Application Number: DA2022/1675

Description:	Alterations and additions to residential developmt - Alterations and additions to a dwelling house including a swimming pool
Application Type:	Development Application
Status:	Under Assessment
Submitted:	11/10/2022
Notification Period:	17/10/2022 to 31/10/2022
Cost of Work:	\$ 918,500
Officer:	Megan Surtees
Submissions:	♦ Make a submission

PROJECT
ALTERATIONS & ADDITIONS
57 CUTLER RD, CLONTARF, NSW 2093
LOT 30, DP 25654

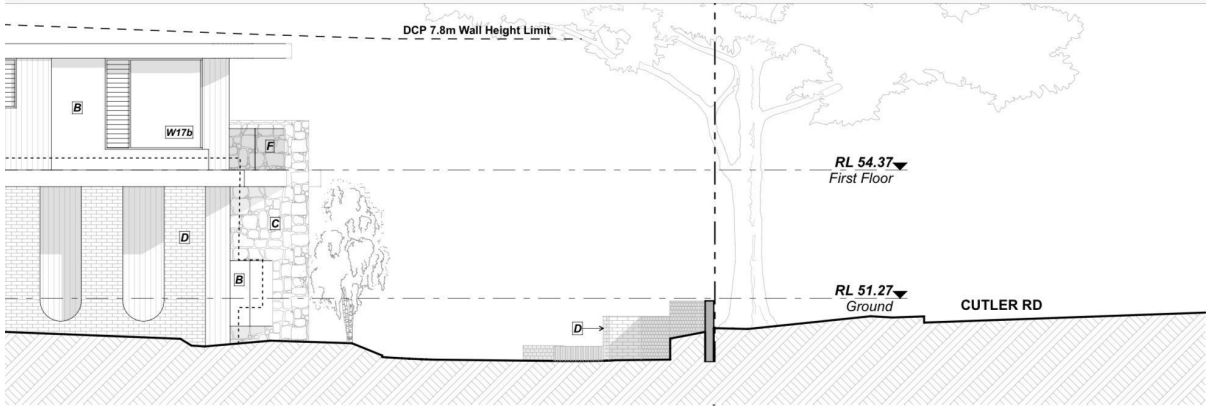
Any new extended level at 57 would have its windows looking straight into my living areas and bedroom. This would cause significant privacy and noise issues. I note that the owners of 57 have recently (in 2020) bricked-up doors and windows facing my property in their long, noisy, full internal gut and renovation. The residents at 57 did not want to be overlooked nor overheard inside their home and neither do we. Hence in the completely unwanted event this development gets approval, I request no windows facing my building are installed due to visual overlooking issues and auditory privacy issues.

Washing line, antennas, satellite dishes, solar panels. I request they all be positioned lower on 57's Western side of their roof where they won't obstruct my views.

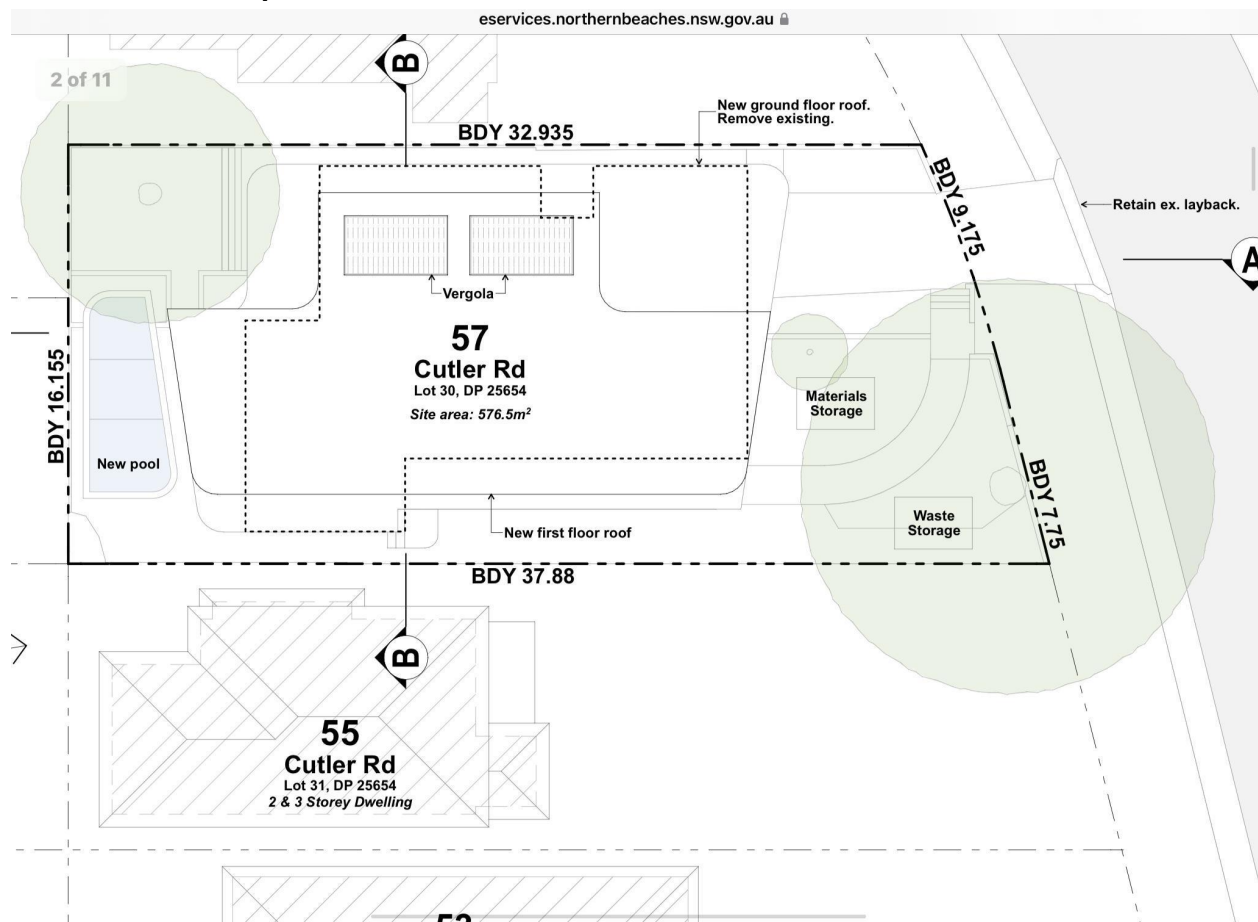
b. 57's pool is within the root Zone and canopy zone of a protected species Angophora Costicata, more than 20 m tall located on the Western boundary of 2A Castle Rock Crescent. Leaves and branches from this tree would constantly fall in the water of any proposed swimming pool built there. Also, the proposed swimming pool is in the root zone and canopy zone of another protected species, another Angophora Costicata more than 30 m tall located beside the South Eastern rear balcony of 57. Leaves and branches would constantly fall in the water of any proposed swimming pool from this tree too. (Picture of 55's living room facing West, 3 meters

from the window looking onto 57's rear garden Angophera Tree).

Currently, my living rooms have an irreplaceable view West to Chinaman's Beach land-sea interface over 57's roof. If a pool was placed in this highly exposed position, it would likely lead to the continuous development of structures to remedy the lack of privacy they would have, further reducing my amenity.

I note that there is only one position not in a critical root stability zone or under a tree canopy for a pool and that is 57's North Western corner near their current garage. I also note there are precedents for front-of-property pools at 59 Cutler Rd and others along Cutler Rd.

Figure 2, showing tree protection area (TPA) adjacent T1

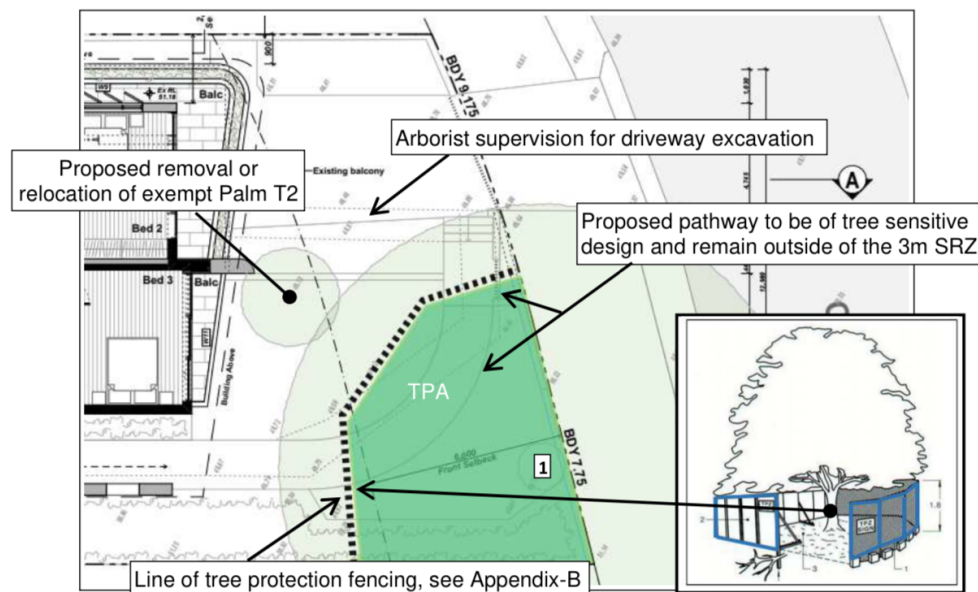
Thus figure 2 above is incorrect. Protected species tree canopy extends nearly over 57's driveway, entrance path and front yard.
